July 18, 2022

**Re: Pitt Meadows Road and Rail Improvements project;  
Harris Road underpass pedestrian and cycling facilities**

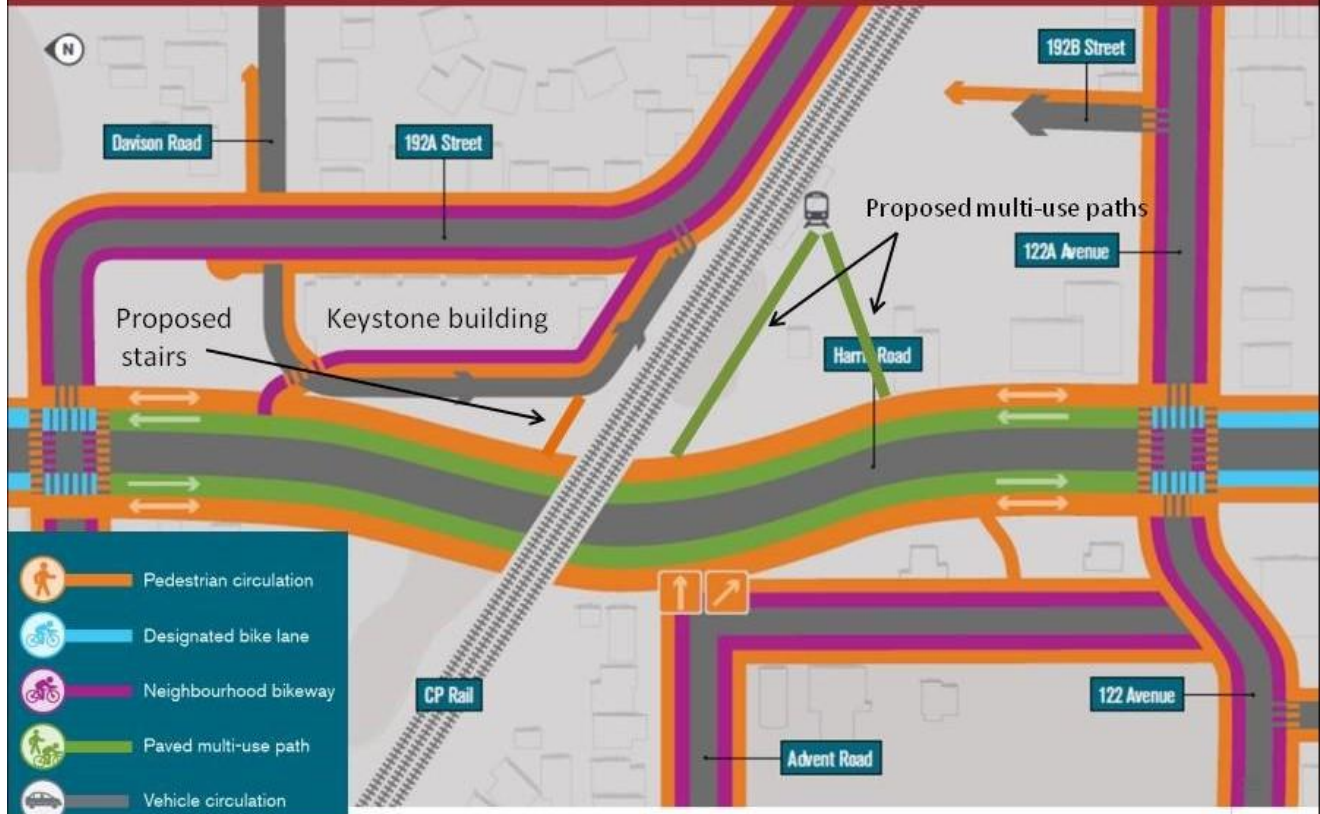
However, when it comes to the combined width of the shared pathways through the underpass, nothing has changed since the initial design. Still at a combined 3 m width on each side, the design **does not meet the absolute minimum standards** as per the BC Active Transportation Design Guide.

- The combined "constrained" or "lower limit" width of the bike path and pedestrian path, including recommended 0.5 m lateral clearance between the bike path and the railing is 1.8 m + 1.8 m + 0.5 m = **4.1 m**.
- If the "absolute minimum" or "practical lower limit" for the bike path is taken as a guide (1.5 m), and if an absolute minimum of 1.5 m would be assumed for the pedestrian path, the combined width would be 1.5 m + 1.5 m + 0.5 m = **3.5 m**.

We continue to strongly support at a minimum 4 m for shared facilities on each side. This is already a compromise from the recommended width.

We challenge the project team to do better than the absolute minimum, and aim for a design of adequate width that will safely and comfortably accommodate active transportation needs well beyond 2050.
